**KING'S MARK  
ENVIRONMENTAL REVIEW TEAM**

**REPORT FOR  
CASTLE LANE SUBDIVISION  
ANSONIA, CONNECTICUT**

Environmental Review Team Report

JULY 1988

## SOILS

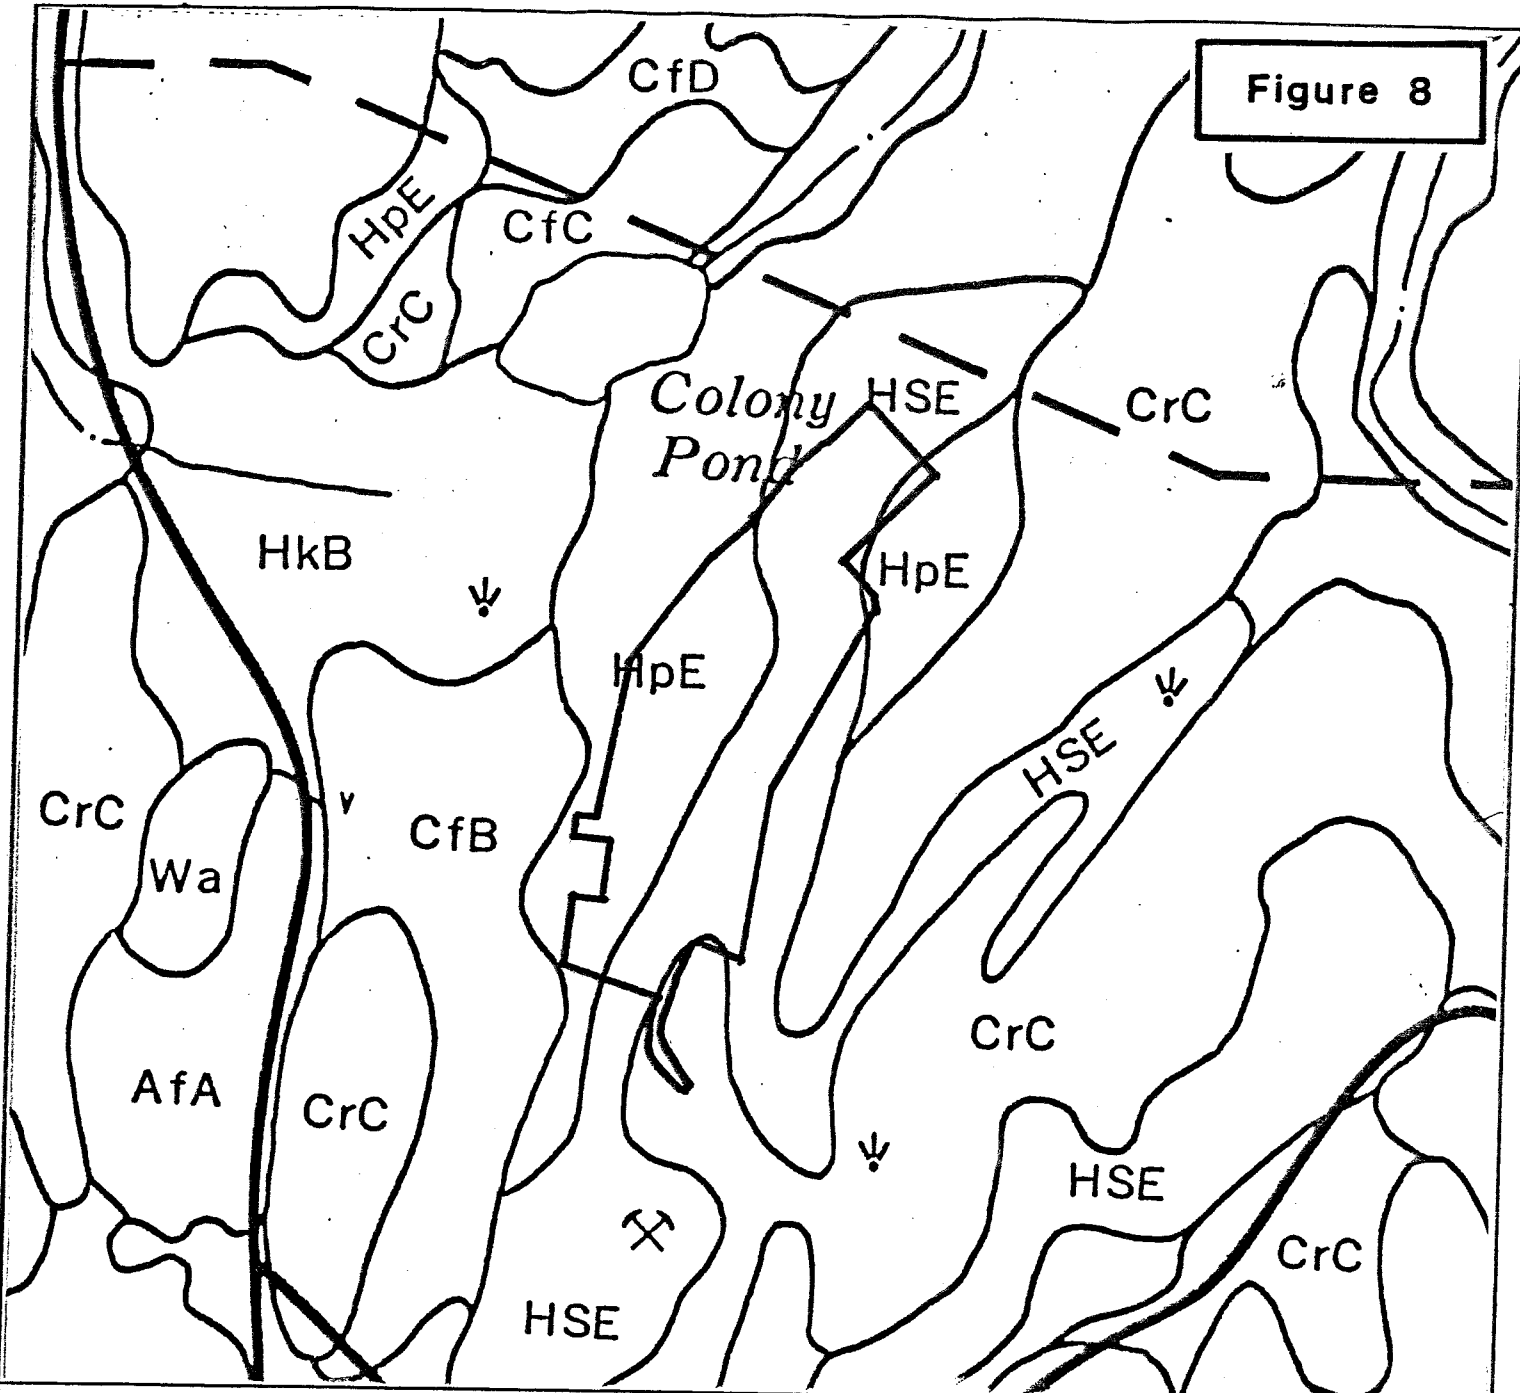
The development could be a severe erosion hazard due to the extensive clearing and grading proposed and the steep slopes with droughty, shallow to bedrock soils. It will be difficult to reestablish vegetation and topsoil will have to be brought in to provide a suitable seedbed. The large amount of rock which would be in the fill material will make proper grading difficult and the creation of concentrated flow areas with high erodibility is likely. Concentrated runoff from roofs and driveways must be safely handled to prevent erosion on the proposed fill slope. Additional rows of sediment barriers are needed considering the size of the disturbed area and slope characteristics. The planned 2:1 cut or fill slopes for most lots will not be usable yard space. These cuts will be difficult for the homeowner to maintain and are more difficult to stabilize initially. Slopes of 3:1 to 5:1 are more desirable.

Other items needed in the sediment and erosion control plan include:

- 1) A narrative section describing the:
  - a) Development,
  - b) Major land uses of adjoining areas,
  - c) Number of acres to be disturbed,
  - d) Application sequence of all Erosion and Sediment Control Measures, and
  - e) Schedule of grading and construction activities;
- 2) Test pit data;
- 3) The disposal procedure for cleared material;
- 4) The location of stockpiled topsoil and subsoil;
